**HaskoningDHV UK Ltd.  
Industry & Buildings**

To: Marine Management Organisation (MMO)  
From: Royal HaskoningDHV  
Date: 22 February 2023  
Copy: Teesworks  
Our reference: PC1084-RHD-EN-SB-ME-EV-1144  
Classification: Confidential  
Checked by: Matt Greaves, Chris Adnitt

**Subject: MLA/2022/00506/2 South Bank Quay Further Information Request 20  
Response**

# Dredging Proposal – Informing MLV2

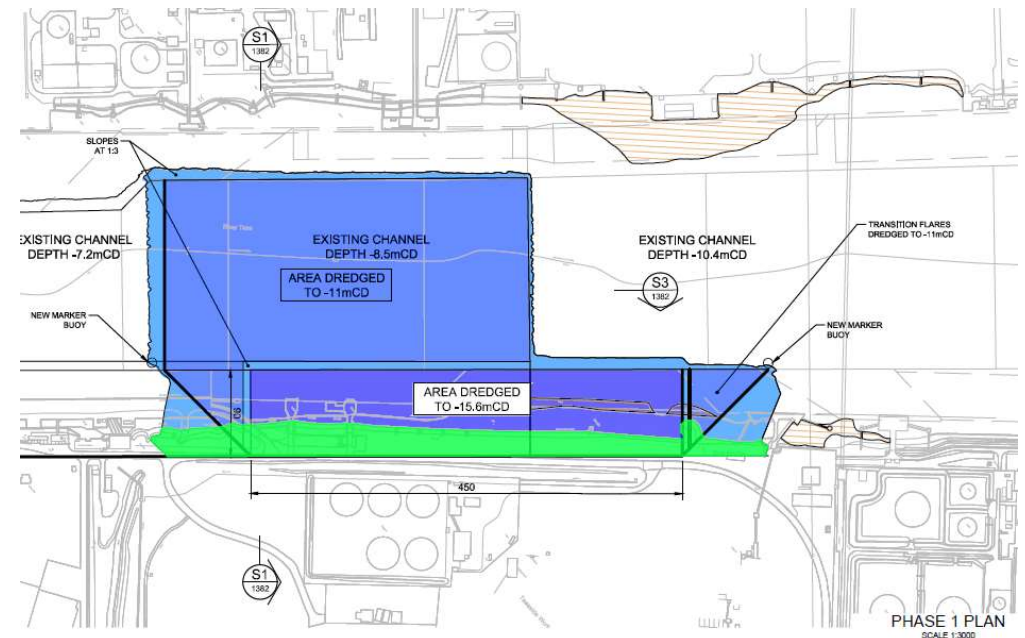
The Applicant notes that there has been no change to the profile or design of the new quay wall (it is only the method of removal of sediment that has changed). Therefore, no change in the final operational

arrangement or habitat to be lost is anticipated as a result of MLV2 (please refer to the supplementary material provided in **Appendix A** illustrating the footprint of the berth assessed within the original EIA Report and at the time of applying for MLV2).

The Applicant notes there is no change in the footprint of material to be removed (or therefore affected habitat) by MLV2 and reiterates that the following points:

- There has been no change to the profile or design of the new quay wall (it is only a change in the method of the removal of sediment under MLV2) and therefore no change in the final operational arrangement (please refer to the supplementary material provided in **Appendix A**);
- The changes requested under MLV2 relate solely to construction methods, specifically changing the method of removing bank material from land-based excavation to dredging; and
- The area applied to be dredged instead of excavated by land-based machinery under MLV2 is an area of made ground overlying geological material. The proposal under MLV2 is to excavate the made ground material and dispose of this to land, then dredge the geological material for disposal at the licenced Tees Bay C offshore disposal site.

Change	Variation
Addition of CSD methodology	MLV1
Modifications to dredge area and depths to suit CSD method	MLV1
Increase in dredge and disposal volume (see green area)	MLV2
